PCN / EOL Notification

Product Change Notification Number: RC103803

Title: AT91SAM7S256 MRL B Revision and Ordering Code Change

Top side marking:

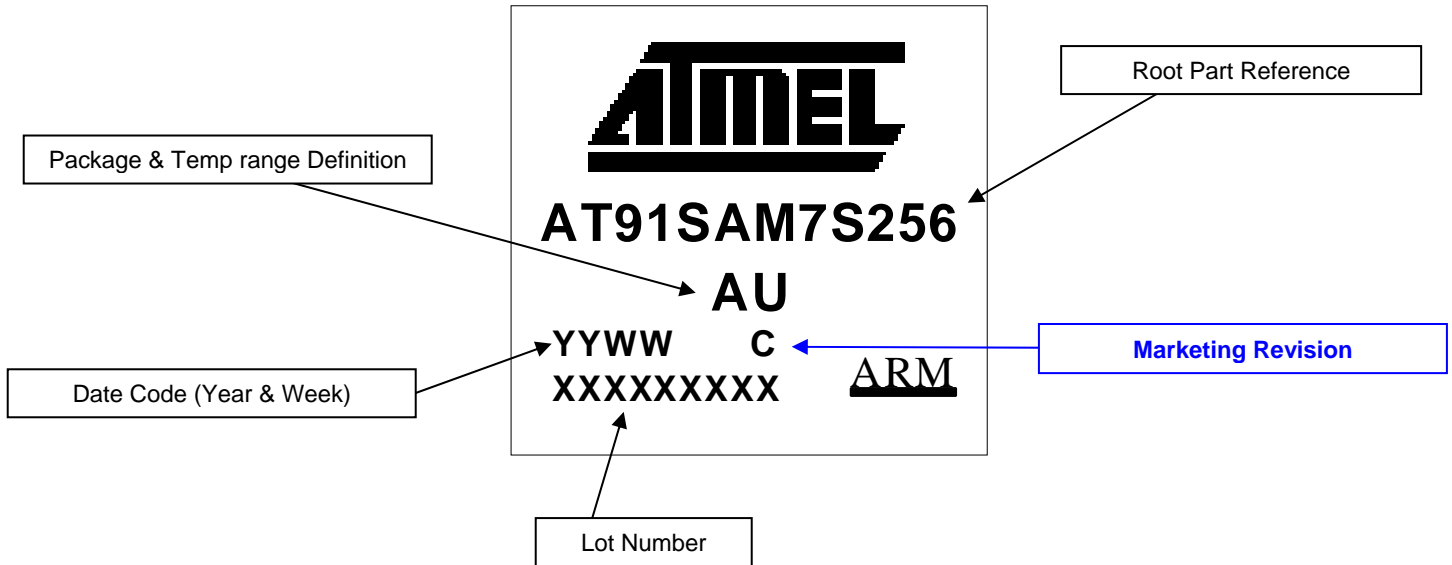
Marketing Revision on the topside marking will be incremented from B to **C**.
